Addendum No. 04

Revisions and Related Responses to Questions & Addenda items # 1 & 2

For RFT2024-01PR

Project: ECC & Arena Renovations

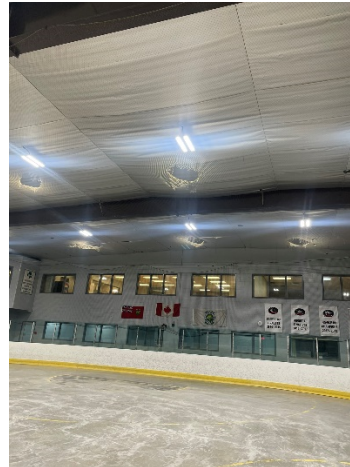
To clarify the scope of work related to arena's protective suspended nylon netting.

1. Delete 10999, item 3.2.4.2. of the specification.
 - a. Revised the scope to replace all existing arena netting.
2. Remove all existing netting, ceiling and vertical.
3. Replace all vertical netting at the end zones.
4. Provide new ceiling netting over the entire ice surface.
